CHANGE ORDER NO.: 1

Owner:	City of San Luis	Owner's Project No.:	2025-050
Engineer:	PACE	Engineer's Project No.:	B777
Contractor:	Filanc	Contractor's Project No.:	
Project:	West WWTP 3.0 MGD MBR Upgrades		
Contract Name:	West WWTP 3.0 MGD MBR Upgrades		
Date Issued:	June 24, 2026	Effective Date of Change Order:	June 24, 2026

CHANGE ORDER REQUEST

CHANGE ORDER TITLE: Potential Scope Adjustment Options

SHEET	C3.0
13 OF 209 SHEETS	
JOB NO. B777

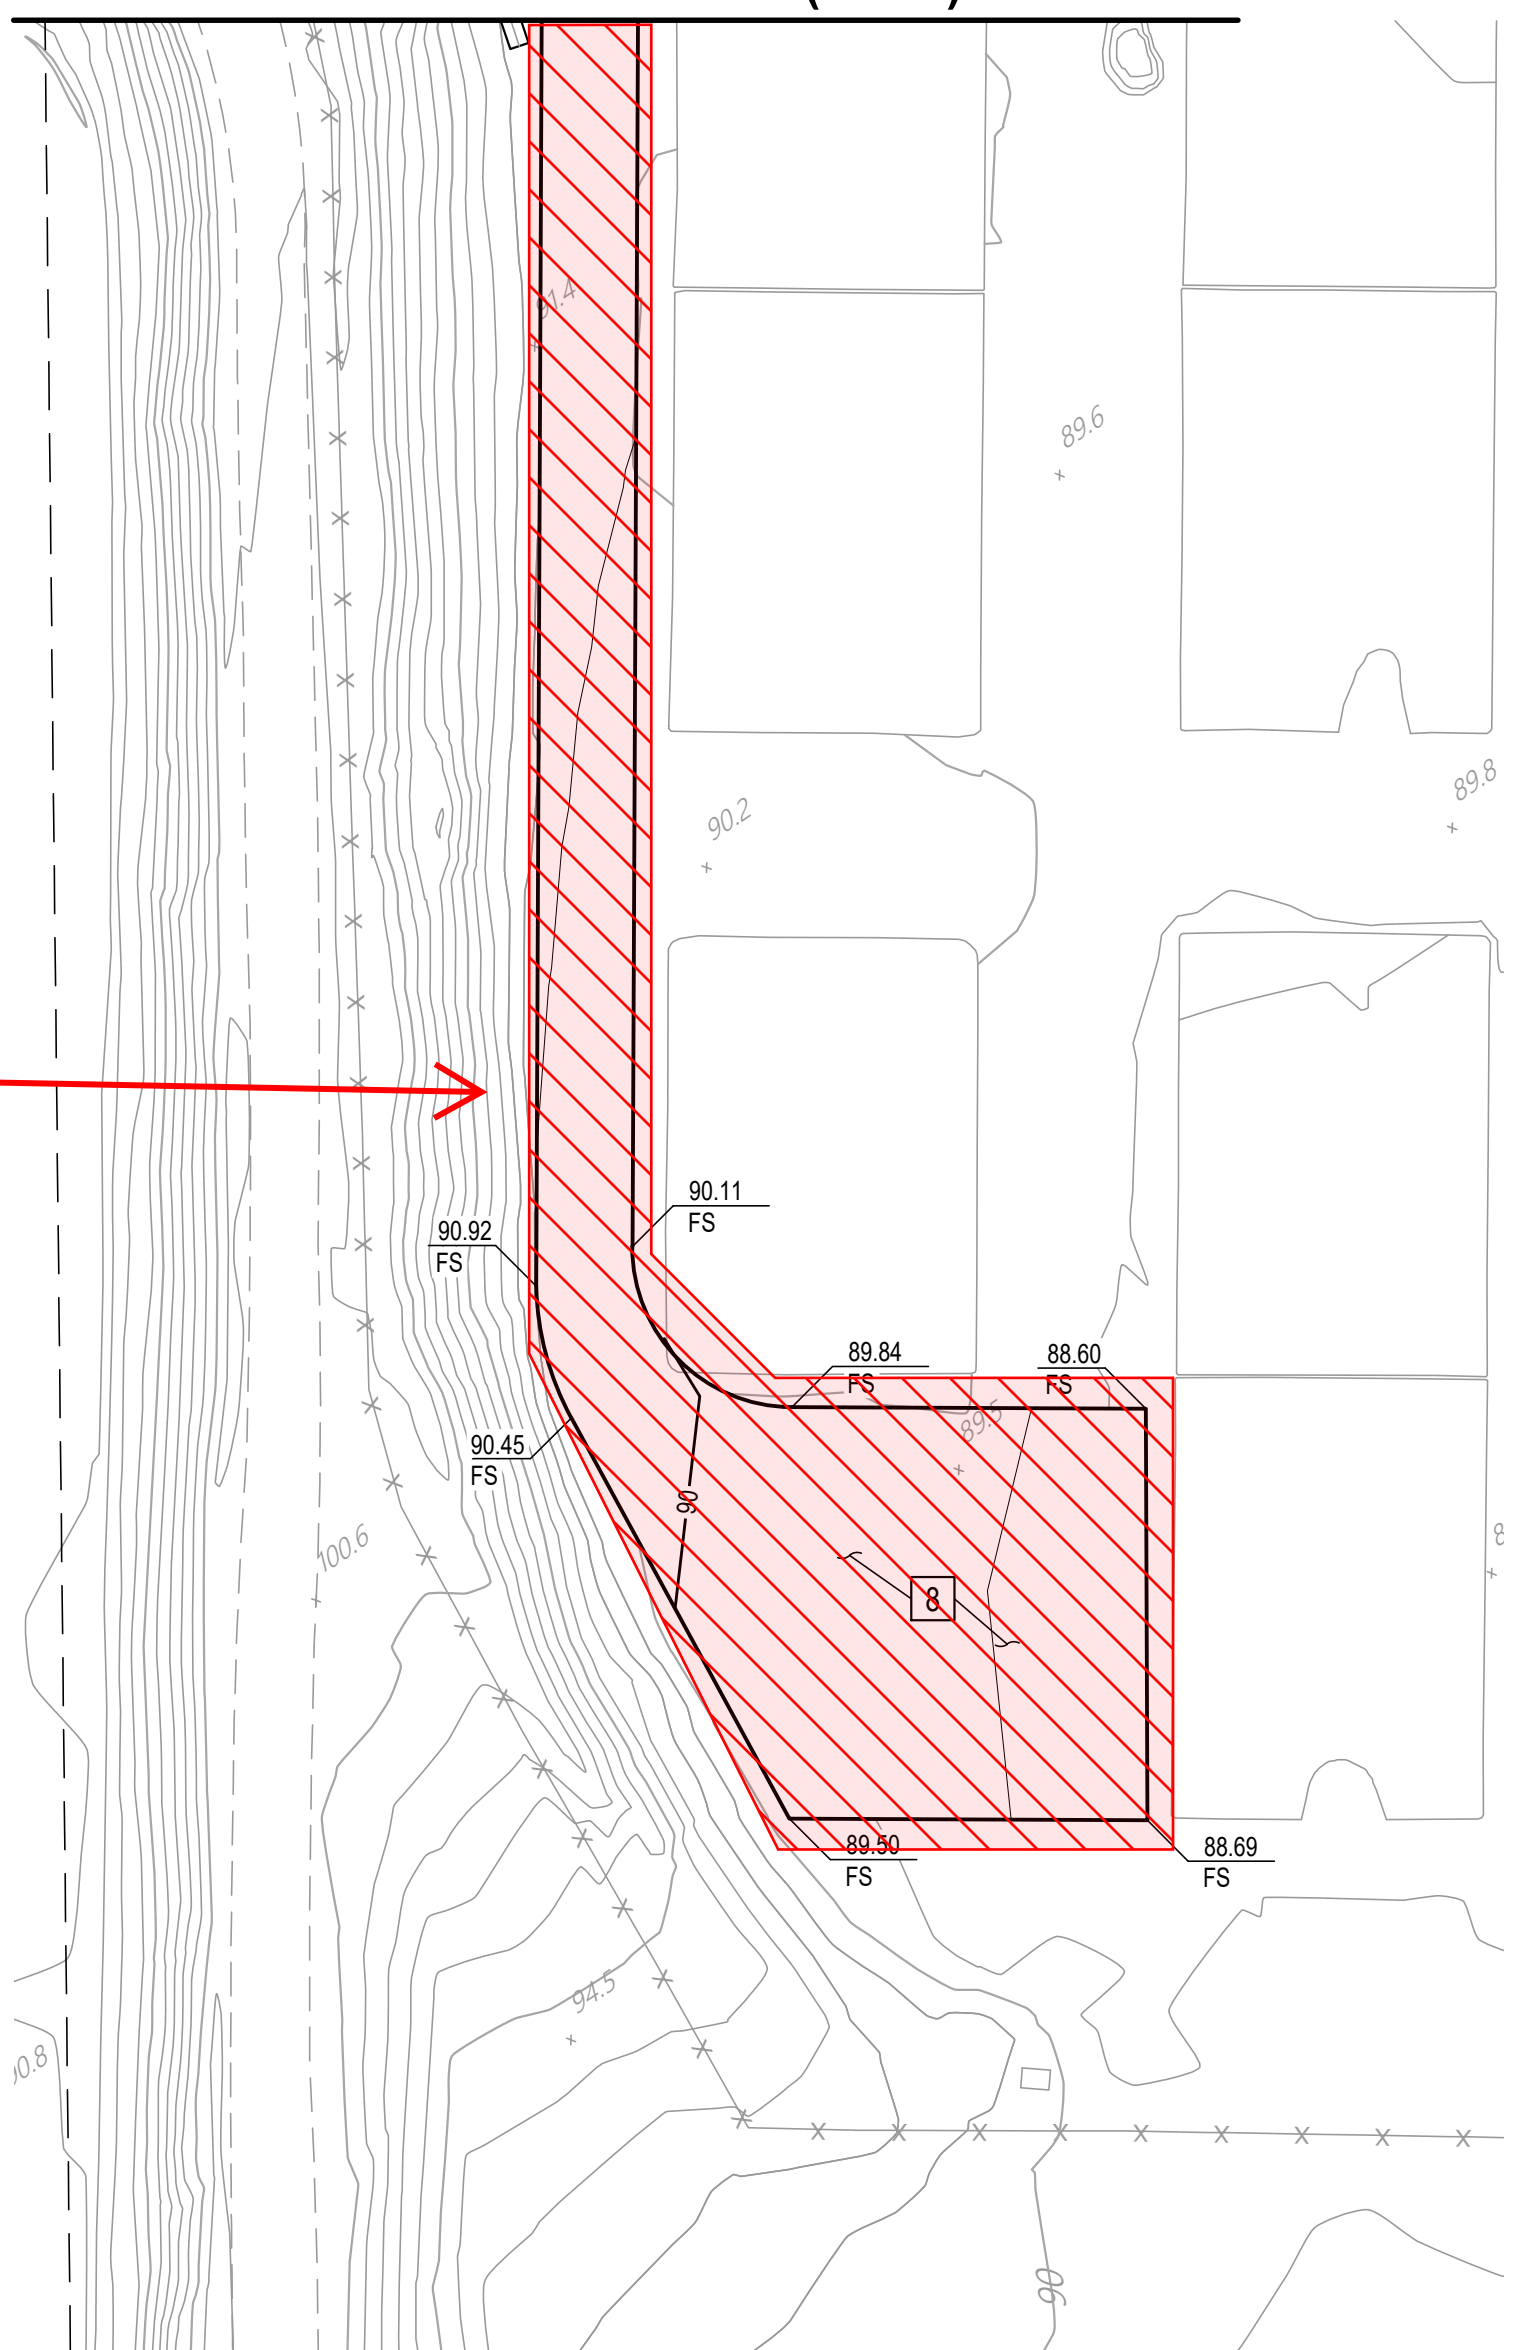
- 1 INSTALL 3" ASPHALT OVER 8" AGGREGATE BASE COARSE PER GEOTECHNICAL REPORT WITH TYPE A THICKENED EDGE PER PER DETAIL: C
C6.0
- 2 INSTALL CONCRETE RETAINING WALL PER STRUCTURAL PLANS.
- 3 INSTALL ACCESS GATE PER DETAIL: D
C6.3
- 4 RELOCATE AND INSTALL NEW CHAIN LINK FENCE WHERE REQUIRED PER DETAIL F
C6.0 MATCH EXISTING.
- 5 INSTALL 3' CONCRETE SWALE PER DETAIL: F
C6.2
- 6 INSTALL PROTECTIVE BOLLARD PER DETAIL: D
C6.2
- 7 INSTALL GATE CARD READER PER CITY SPECIFICATION.
- 8 ~~INSTALL 3' DG OVER COMPACTED NATIVE PER SPECIFICATIONS~~
- 9 REMOVE EXISTING RETAINING WALL.

Owner to provide suitable fill within 300ft of site entrance

- Remove from scope: Install 3" DG over compacted native per specifications on the road leading to the sludge beds (see Sheet C3.0, Note 8)
- Remove from scope: Contractor to demo all structures above concrete pads for abandoned DAF unit (See Attached D1.1)
- Remove from scope: Demo existing sludge pumps. Remove all above grade equipment, piping, and appurtenances of the Existing Sludge Pump. (See Attached D1.1)
- Remove from scope: Demo old odor control system (West unit). Remove all above grade structures, equipment, piping, and appurtenances. (See Attached D1.1)
- City shall provide total sufficient fill import to within 300 feet of the site entrance. City will coordinate with contractor on scheduling of fill.

DEMO SITE PLAN
 SCALE: 1/16" = 1'-0"

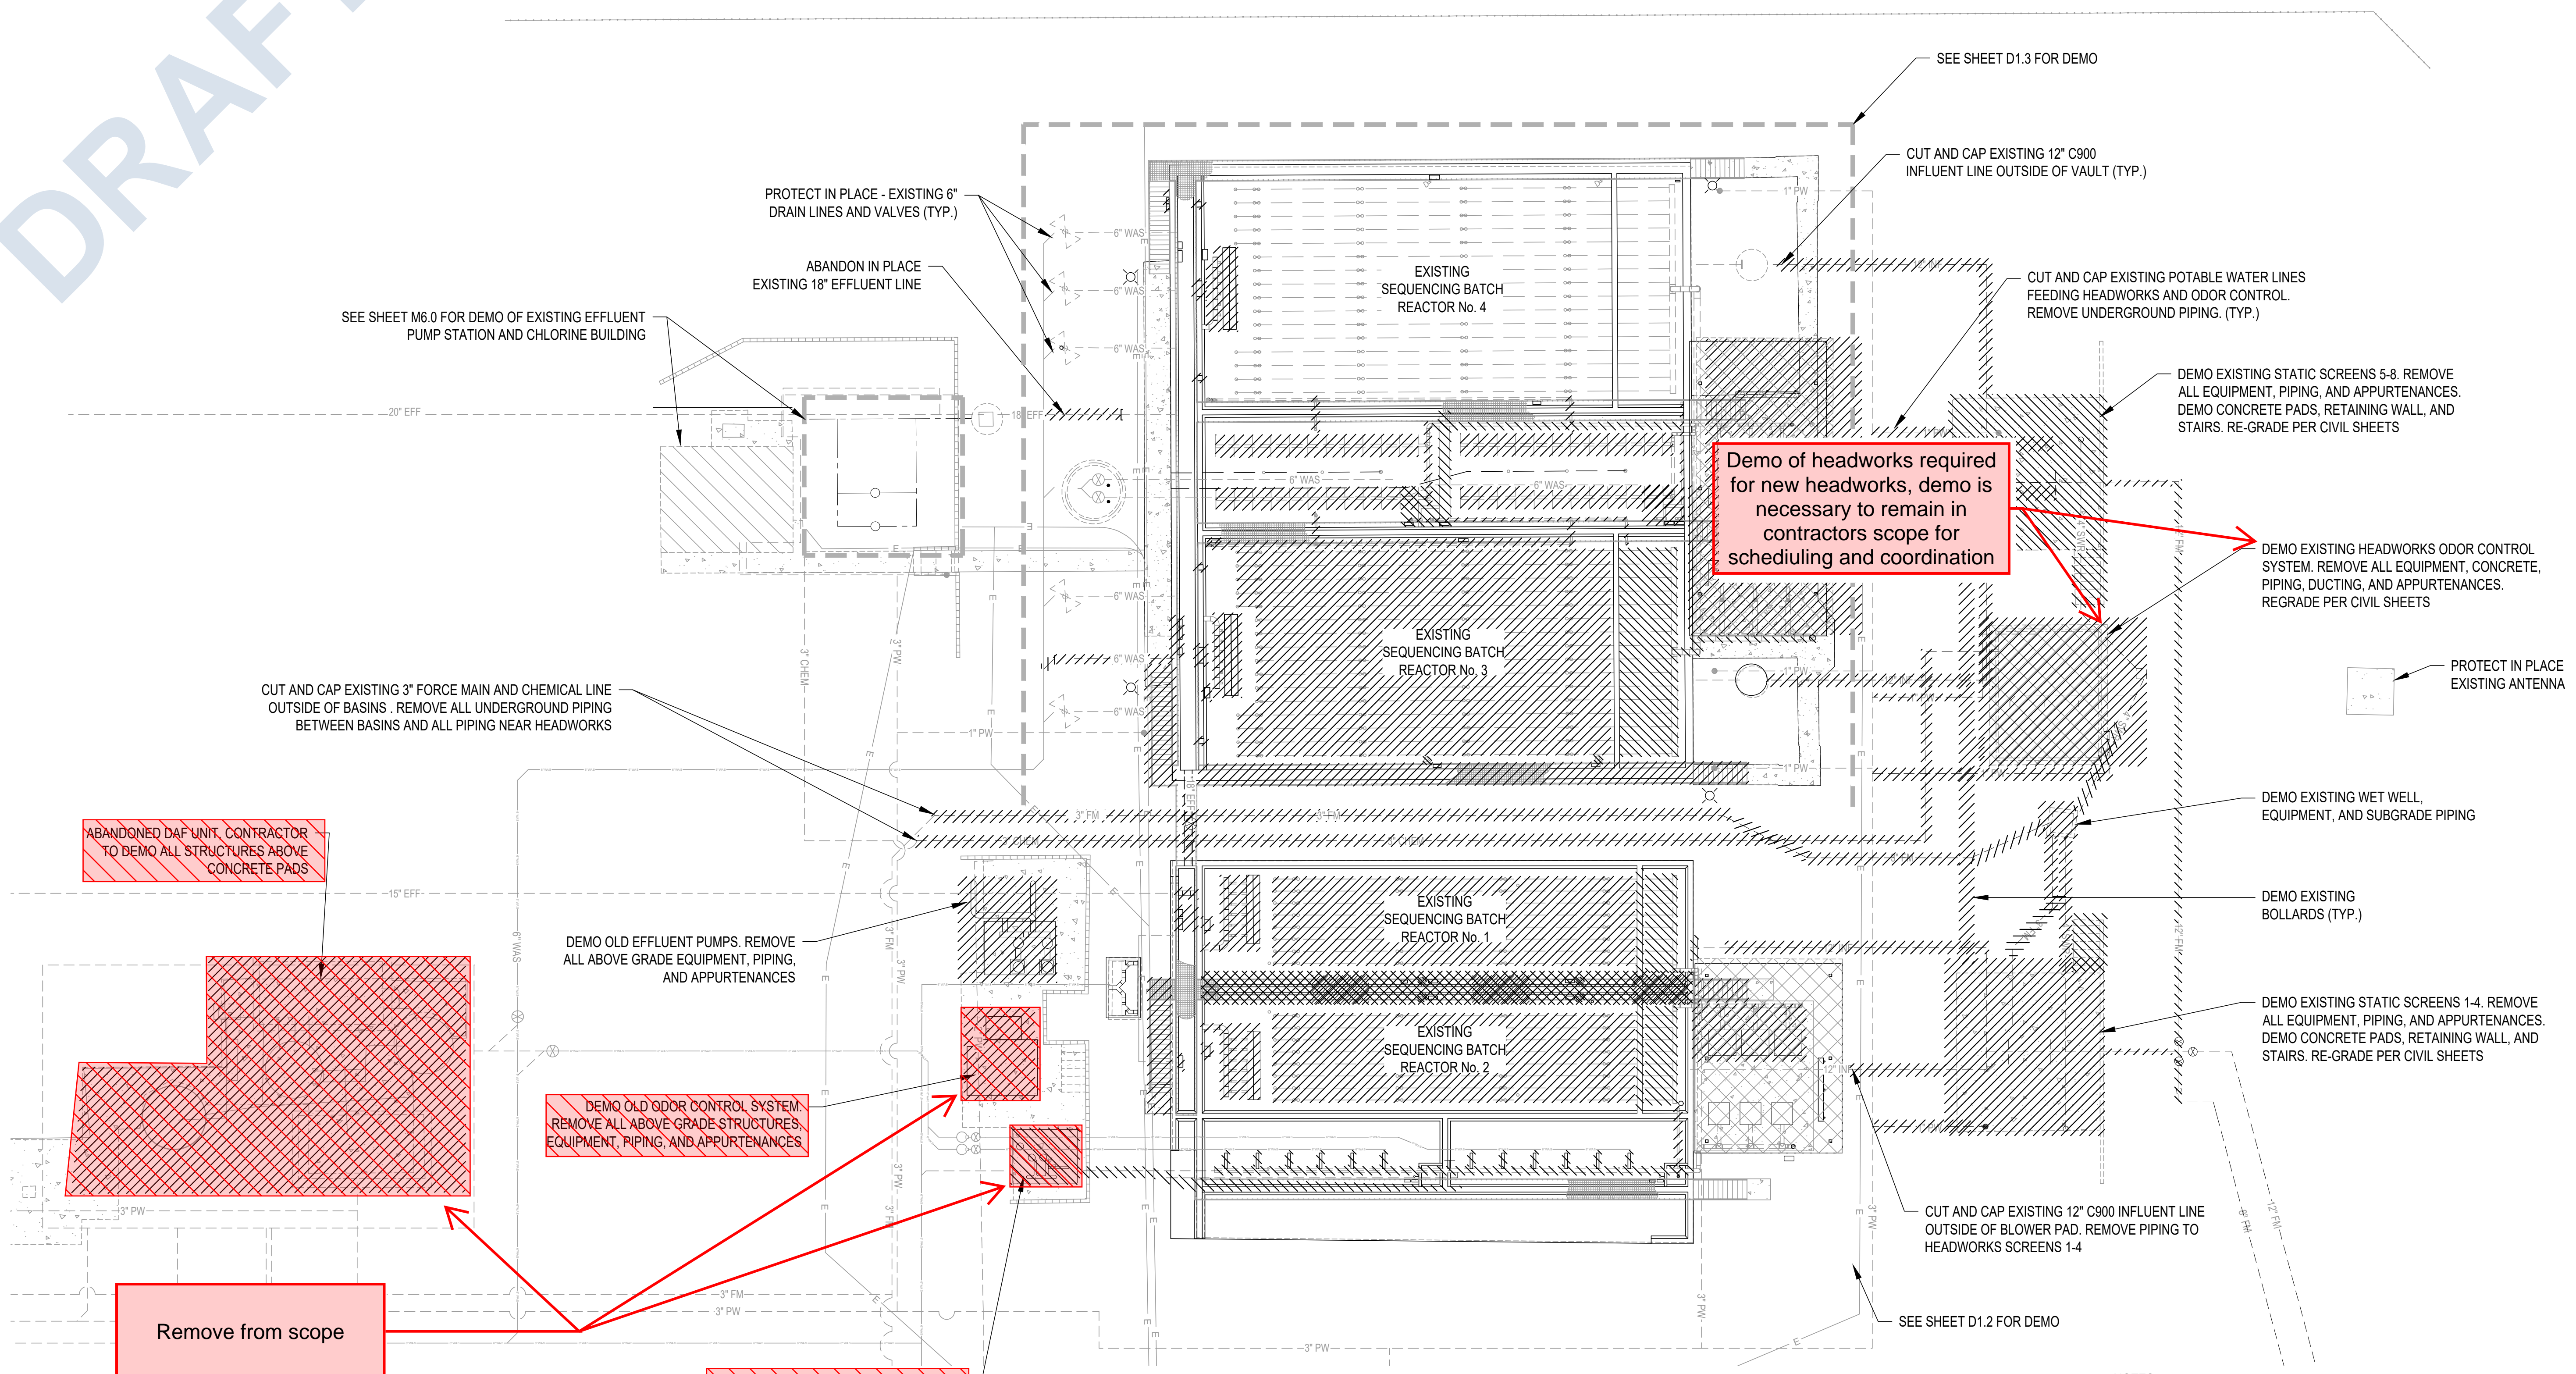
Demo of headworks required for new headworks, demo is necessary to remain in contractor's scope for scheduling and coordination

Remove from scope

EXISTING SBR & DIGESTER BASINS
 SCALE: 1/8" = 1'-0"

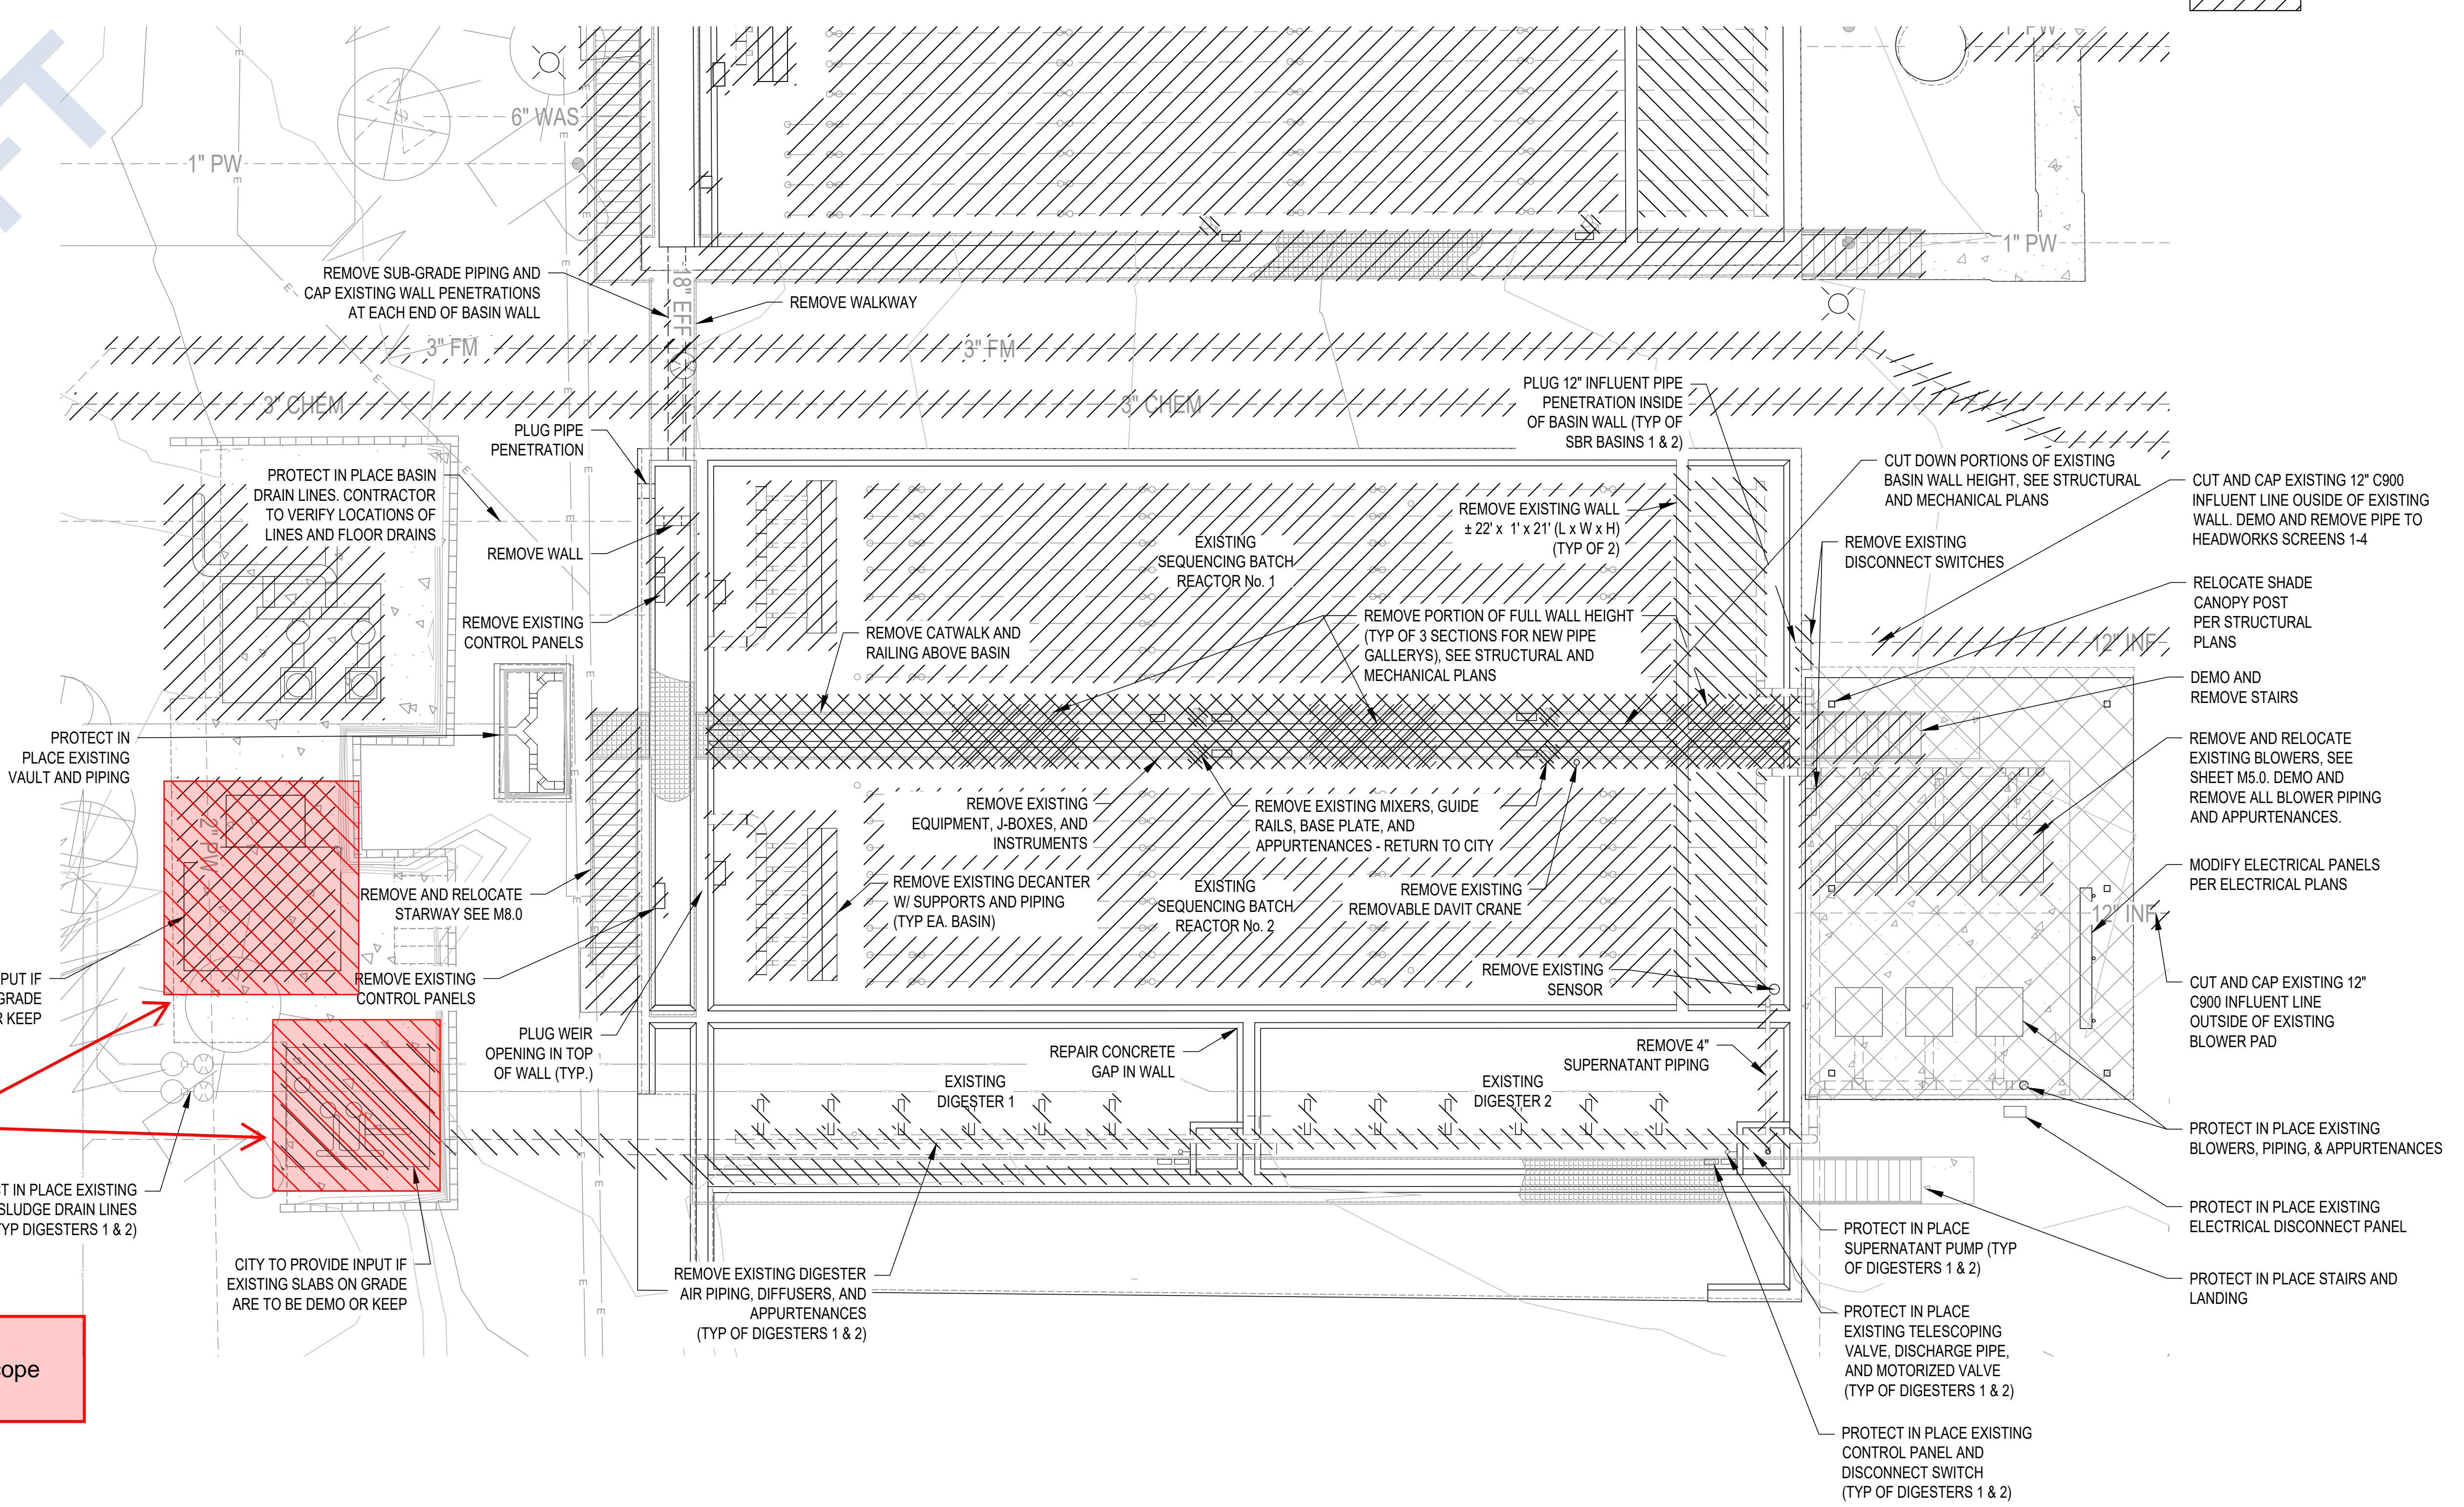
Remove from scope
